Model: Kir-C ARDF (DF71)	Date: 25-May-01	No.: MB379001a
--------------------------	-----------------	----------------

MB Correction

Modified Article: Parts Catalog Correction		Prepared by: K. Miura	
From: Technical Services Dept., GTS Division			
Reason for Modification:	<input checked="" type="checkbox"/> Parts catalog correction	<input type="checkbox"/> Vendor change	<input type="checkbox"/> To meet standards ()
	<input type="checkbox"/> To facilitate assembly	<input type="checkbox"/> To improve reliability	
	<input type="checkbox"/> Part standardization	<input type="checkbox"/> Other

Page 3

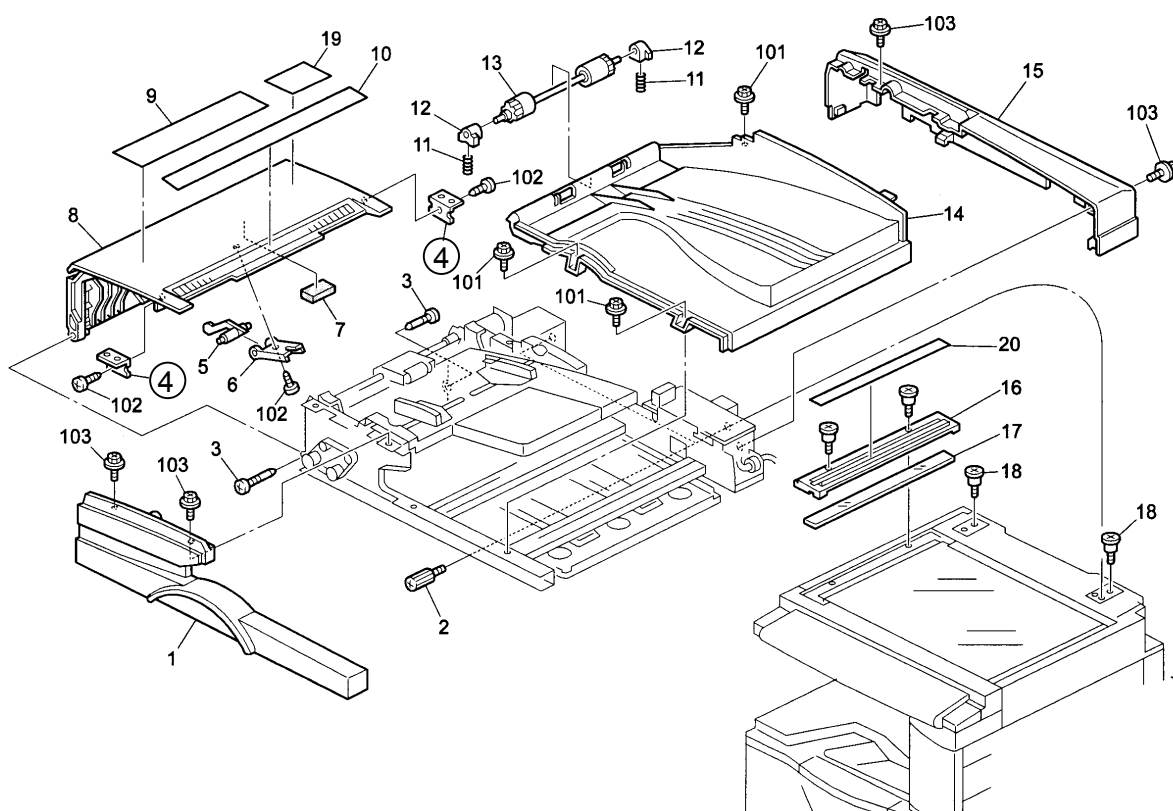
Old part number	New part number	Description	Q'ty	Index	Note
A8594873	B3864873	Positioning Plate	2	4

Page 7

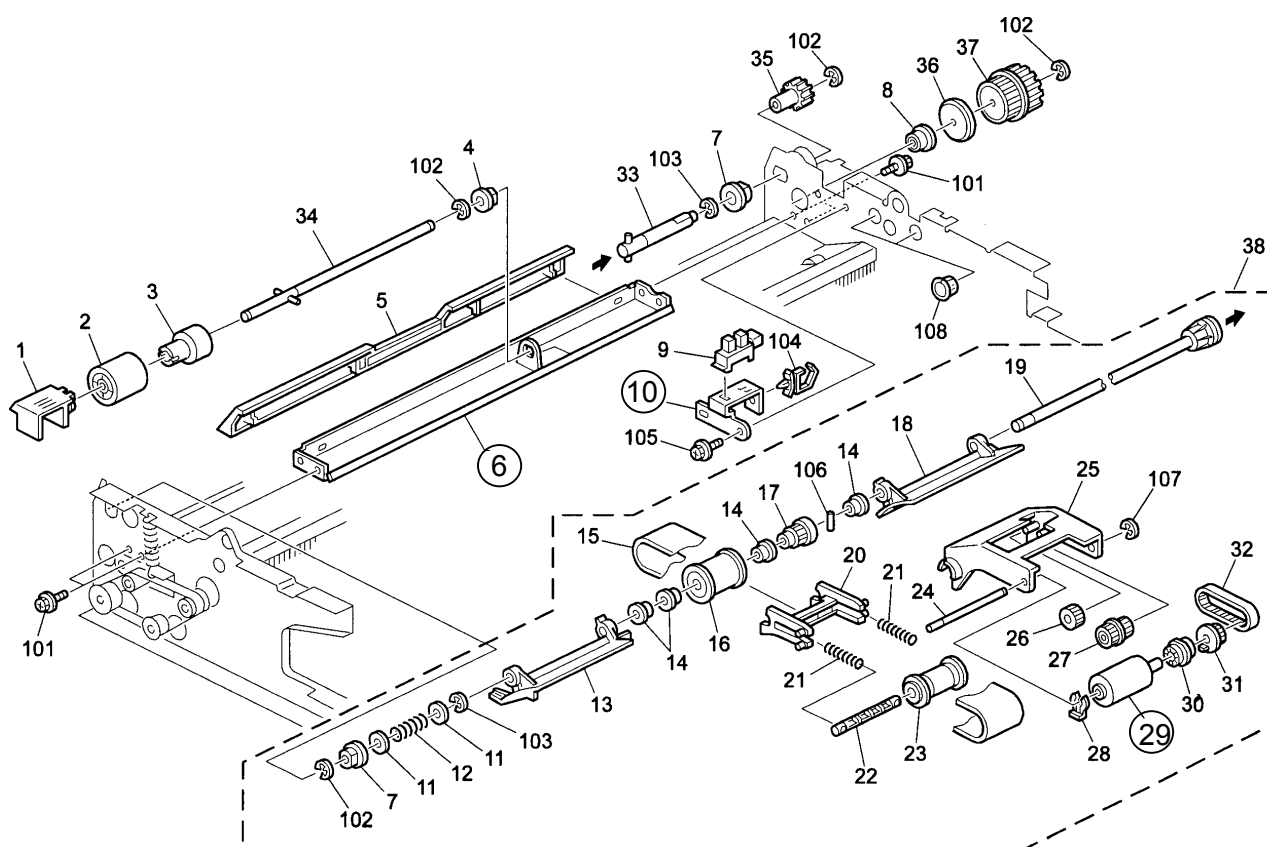
Old part number	New part number	Description	Q'ty	Index	Note
A8591610	B3861610	Separation Stay	1	6	
A8591123	B3861123	Bracket – Sensor	1	10	
A8592161	B3862171	Pickup Roller	1	29

Page 9

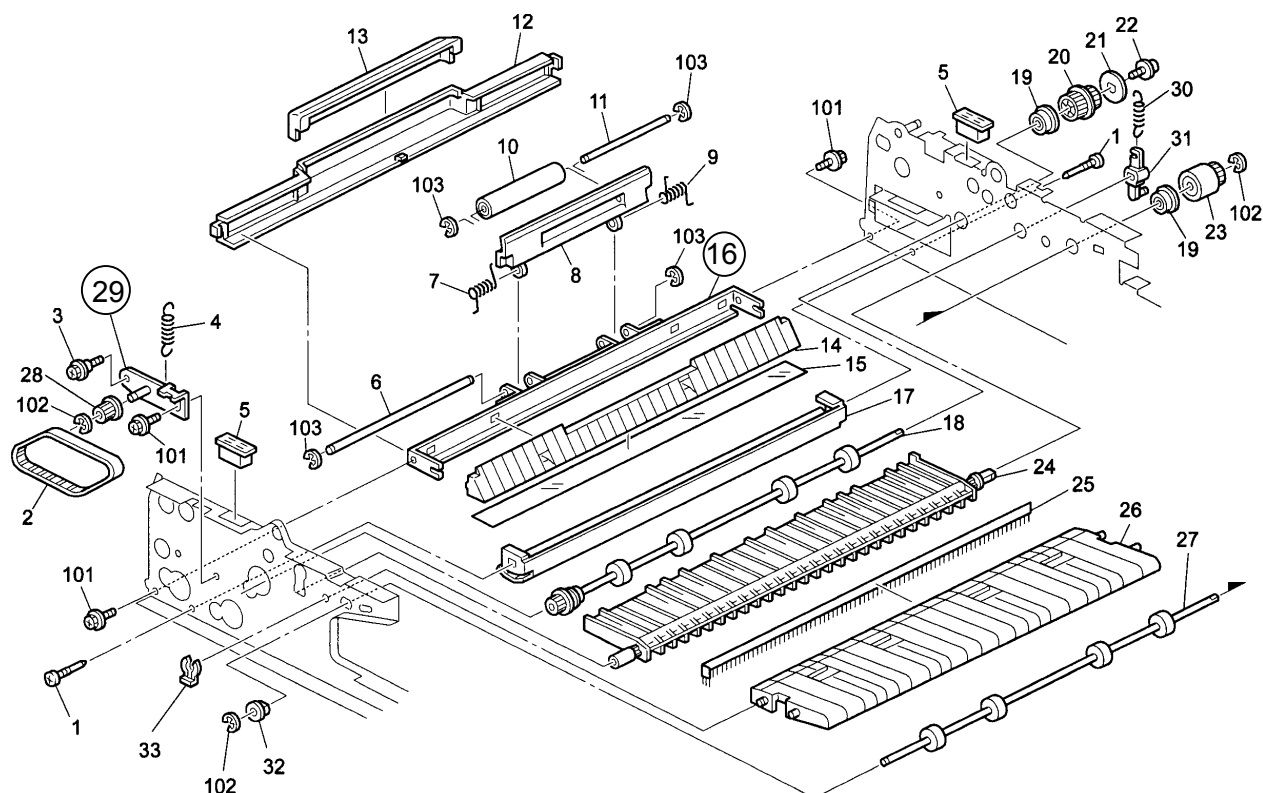
Old part number	New part number	Description	Q'ty	Index	Note
A8591710	B3861710	Left Lower Stay	1	16	
A8594311	B3864311	Adjusting Pin – M6	1	29

Page 11

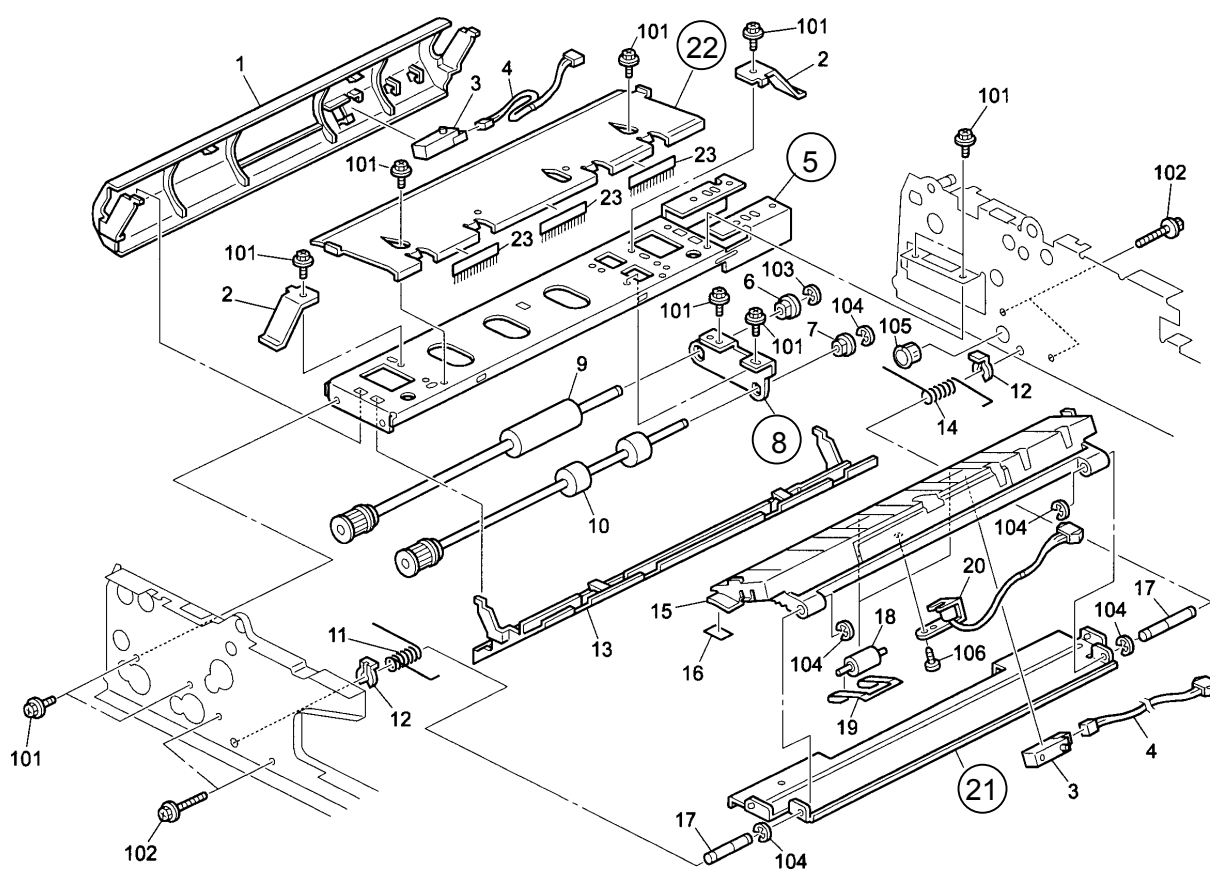
Old part number	New part number	Description	Q'ty	Index	Note
A8591311	B3861311	Left Stay	1	5	
A8591320	B3861320	Bracket – Transport Roller	1	8	
A8593413	B3863413	Cover – Exit Guide Plate	1	21	
A8583231	B3863231	Guide Plate – Reverse	1	22

Page 13

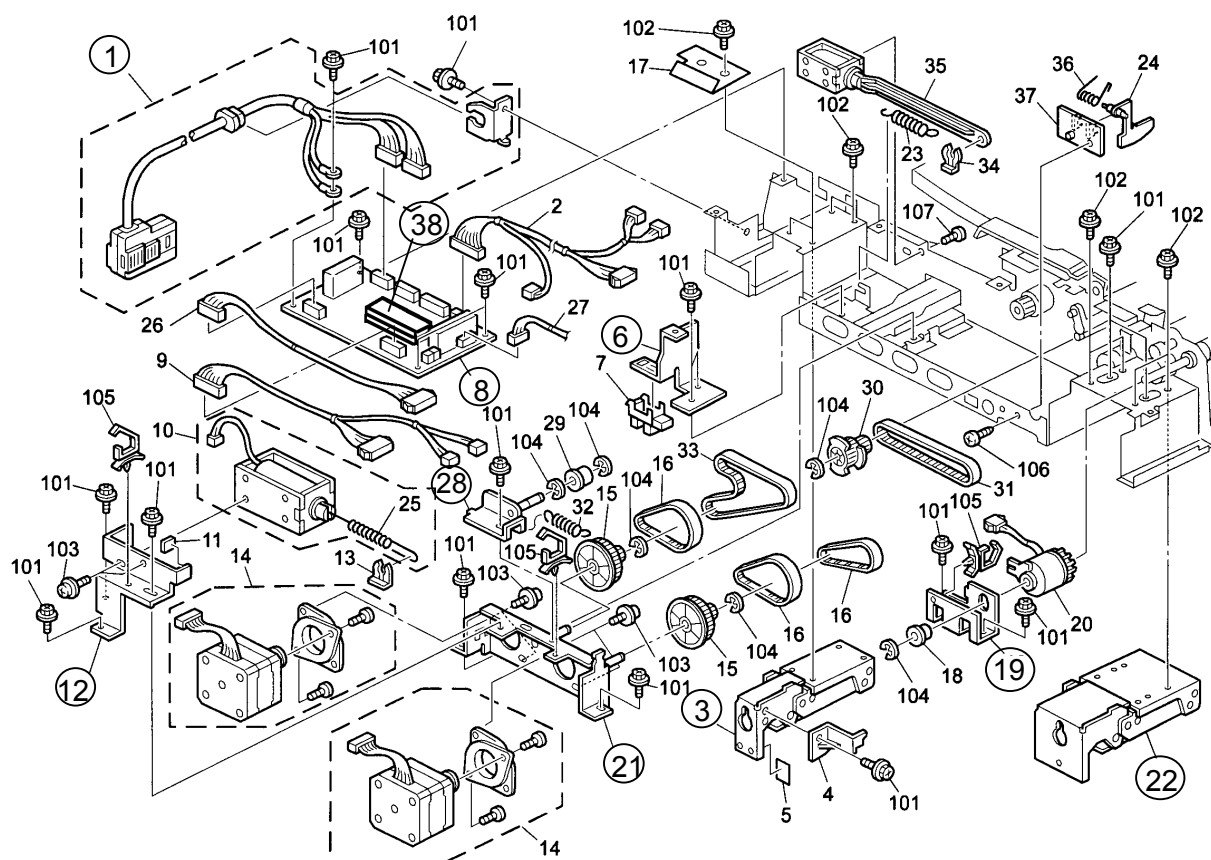
Old part number	New part number	Description	Q'ty	Index	Note
A8595800	B3795800	Harness – Interface	1	1	
A8581831	B3861831	Right Hinge	1	3	
A8591122	B3861122	Right Sensor Bracket	1	6	
B3795500	B3795510	Main Control Board	1	8	
A8594411	B3864411	Bracket – Solenoid	1	12	
A8591315	B3861315	Bracket – Electromagnetic Clutch	1	19	
A8584111	B3794111	Bracket – Motor	1	21	
A8581811	B3861811	Left Hinge	1	22	
A8584131	B3794131	Adjusting Pin - Idler	1	28

Part number	Description	Q'ty	Index	Note
B3875660	ADF ROM	1	38

Page 15

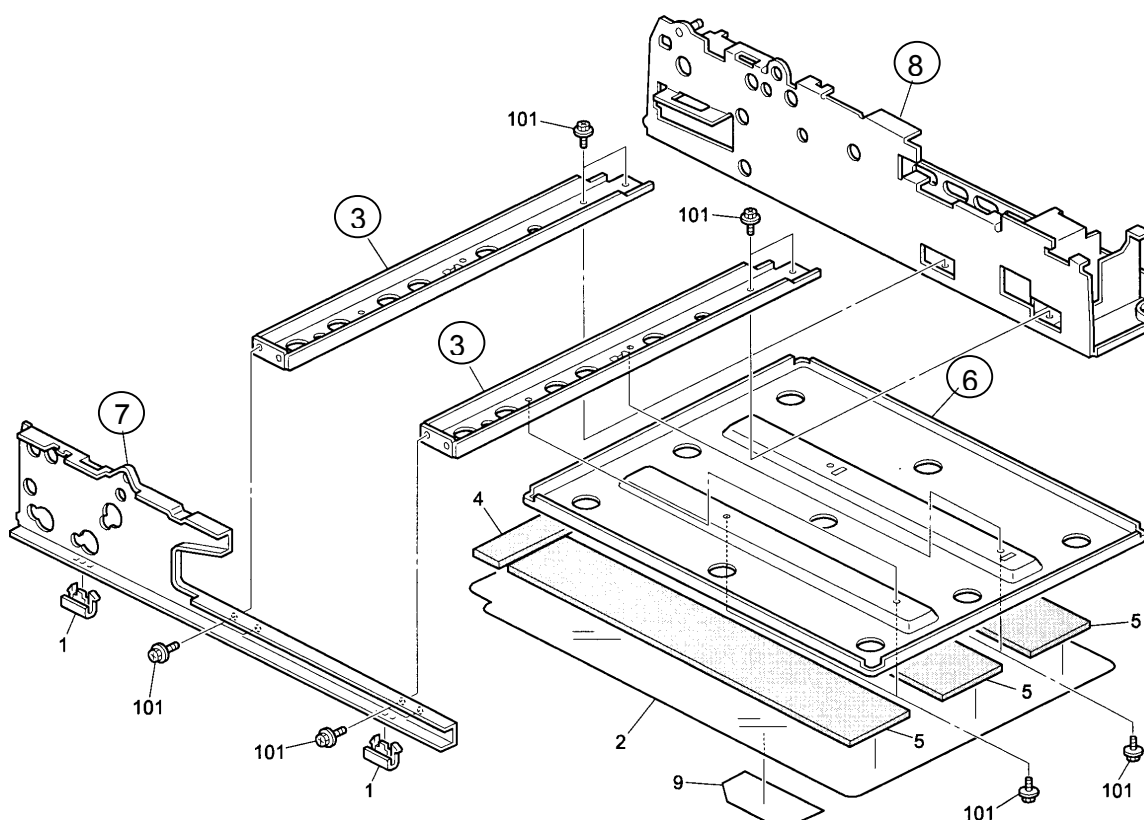
Old part number	New part number	Description	Q'ty	Index	Note
A8591511	B3861511	Middle Stay	2	3	
A8593615	B3863615	Base - Platen Cover	1	6	
A8591211	B3861211	Front Side Plate	1	7	
A8591110	B3861110	Rear Side Plate	1	8

Page 9

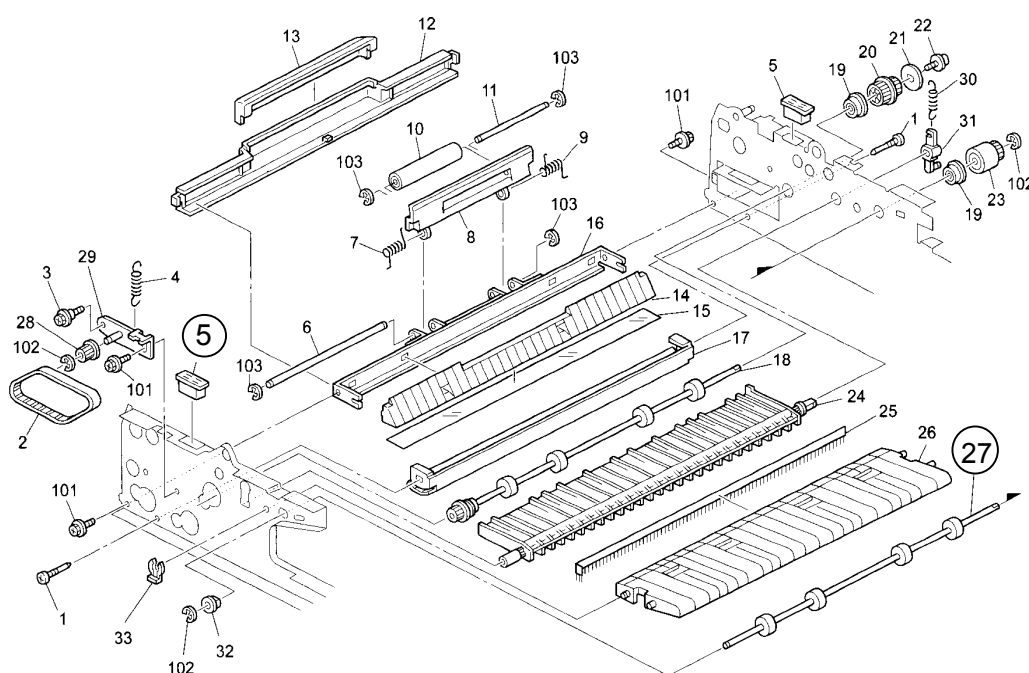
Old part number	New part number	Description	Q'ty	Index	Note
A8591181	B3514135	Magnet Catch - Original Table	1	5	
A8583140	B3863140	Reverse Roller – Drive	1	27

Page 13

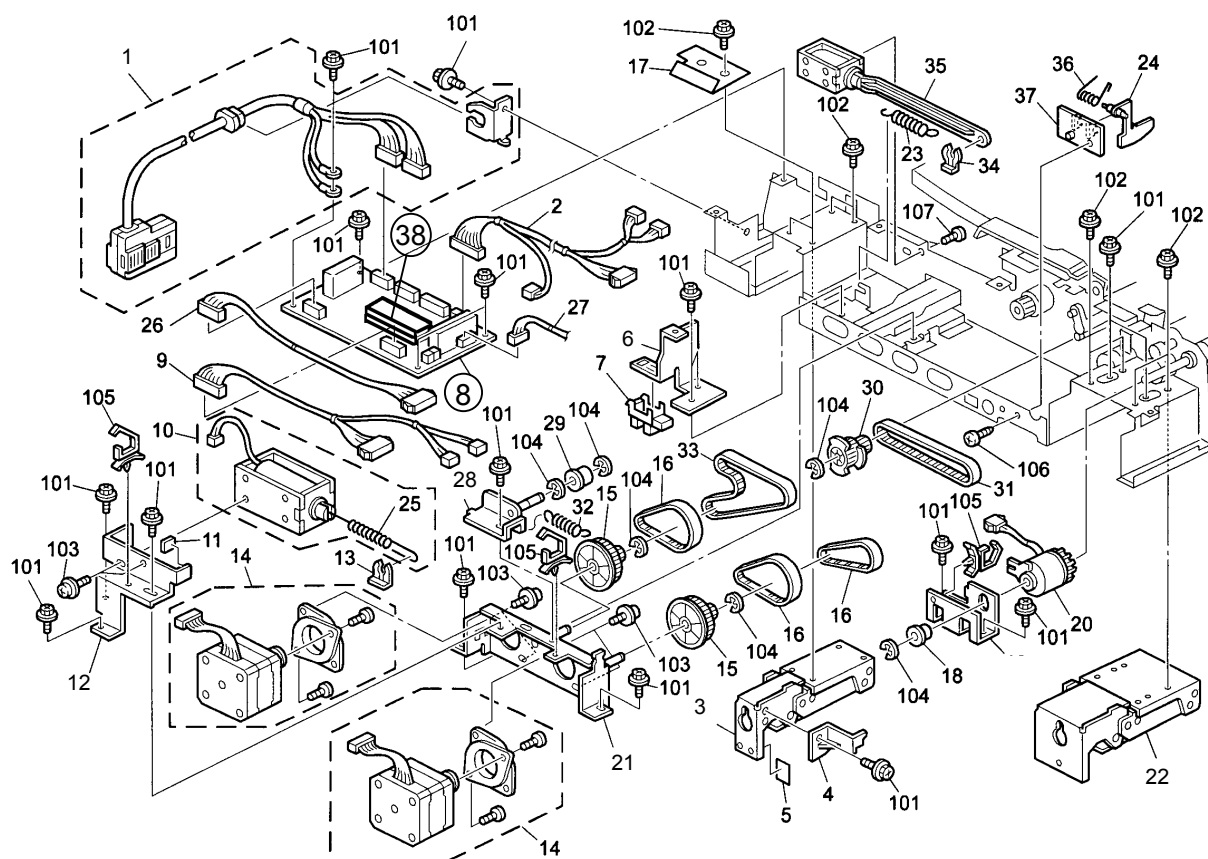
Old part number	New part number	Description	Q'ty	Index	Note
B3795510	B3795520	Main Control Board	1	8	
B3875660	B3875680	ADF ROM	1	38

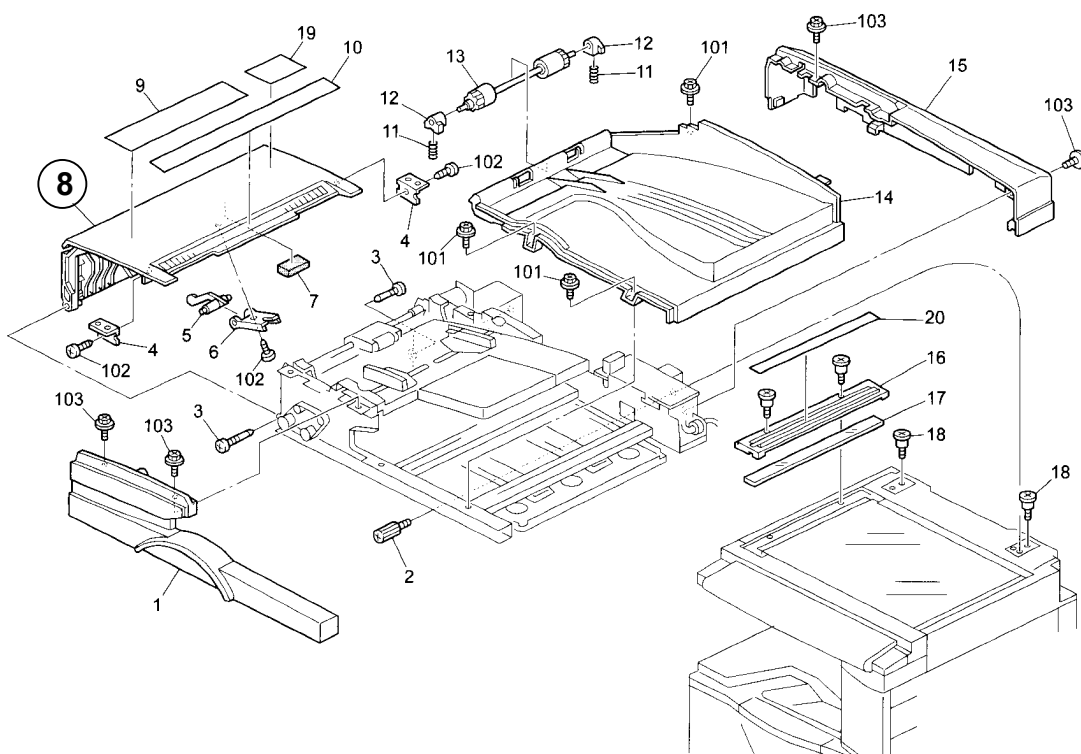
When the document approaches the Transport Rollers, it can sometimes contact the pullout lever due to warping in the Left Cover. The left cover has been changed to reduce the possibility of this happening.

Old part number	New part number	Description	Q'ty	Int	Page	Index	Note
B3864841	B3864842	Left Cover	1	X/O	3	8

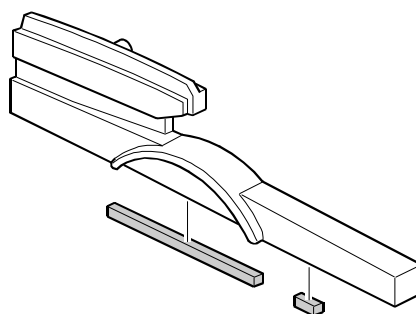
The following protective padding has been added to facilitate handling of the Platen Cover sheet.

New part number	Description	Q'ty	Page	Index	Note
A8584871	Cover Sponge - Front	1	3	21	
A8584872	Cover Sponge - Front Right	1	3	22

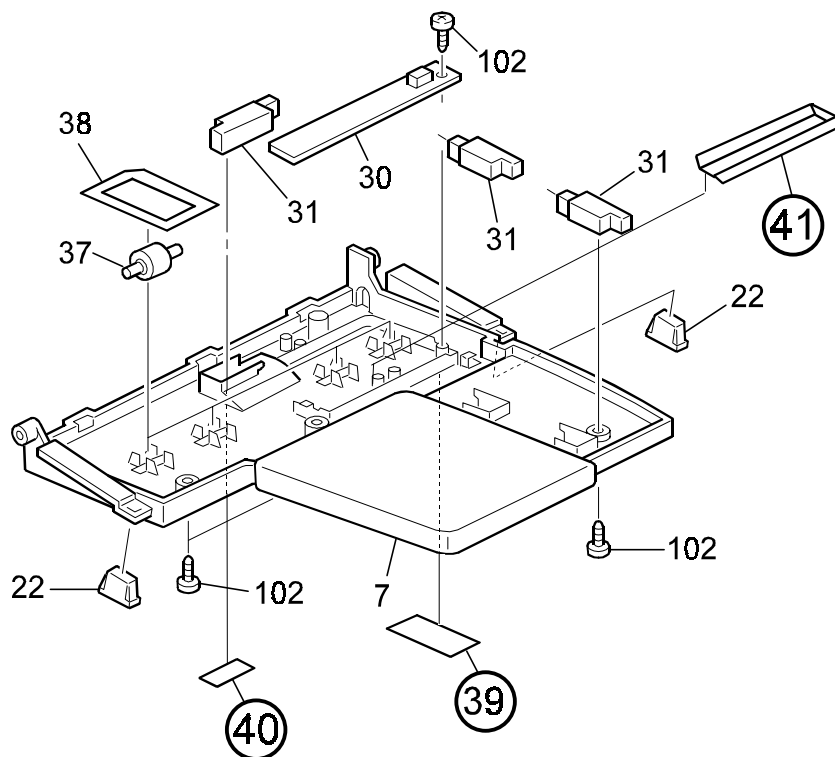
To cover the holes near the sensors and provide further shielding from static electricity, the following seals have been added.

New part number	Description	Q'ty	Page	Index	Note
B3864691	Mylar Seal - 28X107	1	5	39	
B3864692	Mylar Seal - 16X45	1	5	40	
B3864693	Mylar Seal	1	5	41

NOTE:

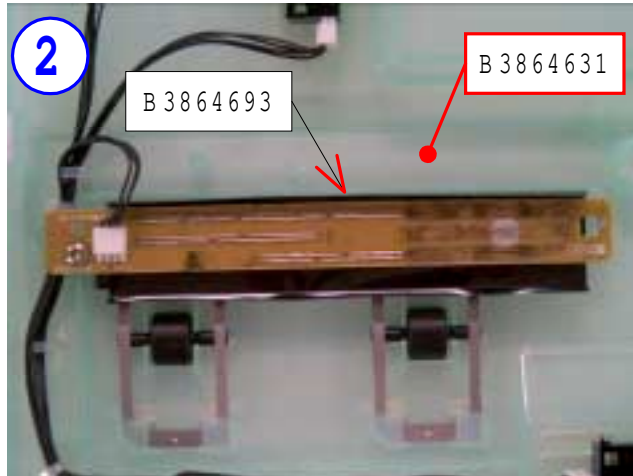
The Mylar Seal (B3864693) should be positioned **below** the Paper Size Sensor Board (B3865540) as shown:

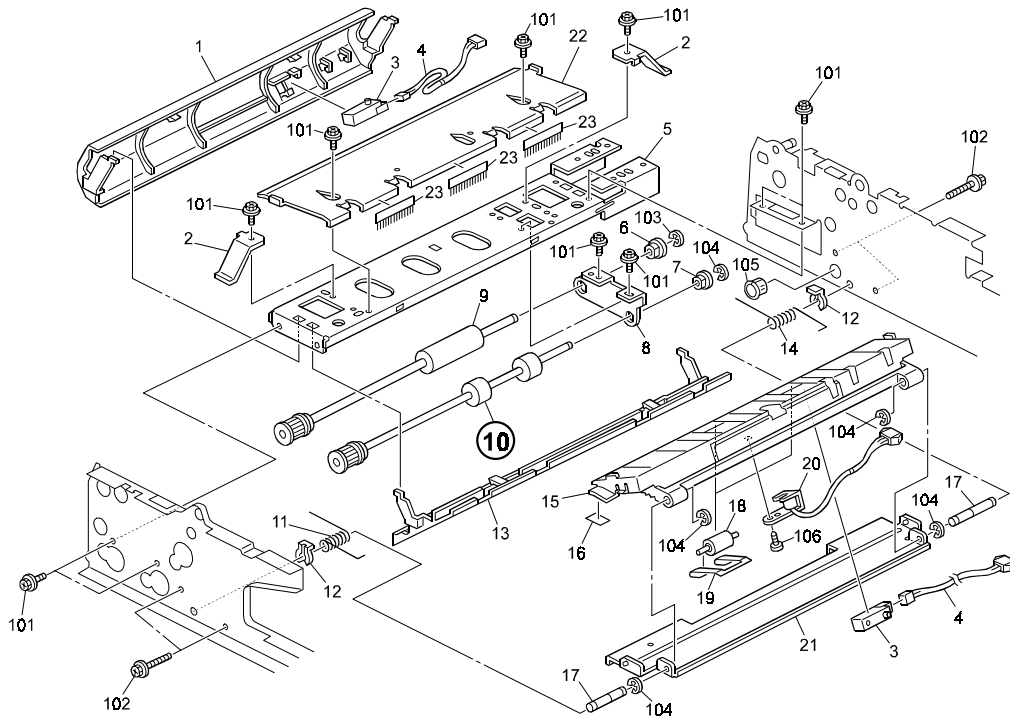
The following part has been changed due to a vendor change.

Old part number	New part number	Description	Q'ty	Int	Page	Index	Note
A8593120	B3863121	Transport Roller - Middle	1	O/O	11	10
